Description of Use Addition to Single
family dwelling

RESIDENTIAL PLAN CORRECTION SHEET

ADDENDUM to Permit No. 174-78
Owner RUDOLPH
Location 14 BROWNELL

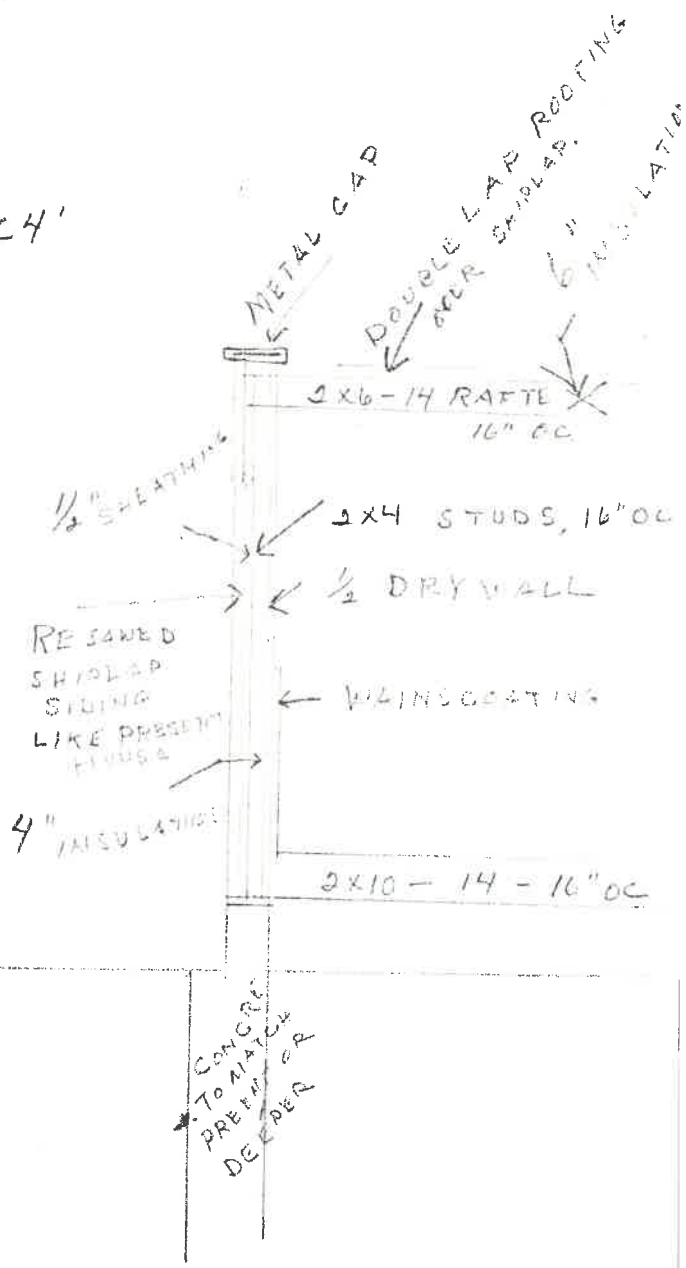
<input checked="" type="checkbox"/>	Provide anchor bolts 1/2" @ 8' o.c. 1' from each corner. Embedded 8" concrete and 15" in masonry.
<input type="checkbox"/>	Show size of basement columns.
FRAMING:	
<input type="checkbox"/>	Show size of wood girder in.....
<input type="checkbox"/>	Provide design data for structural member in.....
<input type="checkbox"/>	Floor joists under sized in.....
<input type="checkbox"/>	Provide double joists under parallel partitions.
<input checked="" type="checkbox"/>	Provide 1" x 4" let in corner bracing or approved sheathing.
<input type="checkbox"/>	Show size of headers for openings over 4' wide.
ROOFING:	
<input type="checkbox"/>	Show size of members supporting porch roof.
<input type="checkbox"/>	Provide double top plate.
<input type="checkbox"/>	Provide design data for pre-fab. wood truss/members.
<input type="checkbox"/>	Ceiling joists undersized in.....
<input type="checkbox"/>	Roof rafters undersized in.....

<input type="checkbox"/>	Provide 15# felt underlayment on roof.
<input checked="" type="checkbox"/>	Provide adequate fireplace hearth extensions
<input checked="" type="checkbox"/>	Install factory built fireplaces/stoves according to manufacturers recommendations.
<input checked="" type="checkbox"/>	Terminate chimney 3' above roof or 2' above highest point of building within 10' of chimney.

ADDITIONAL CORRECTIONS: USE 2"x6" RAFTERS OF HIGH FIBER STRESS & ELASTICITY OR 2"x8" 16" o.c.
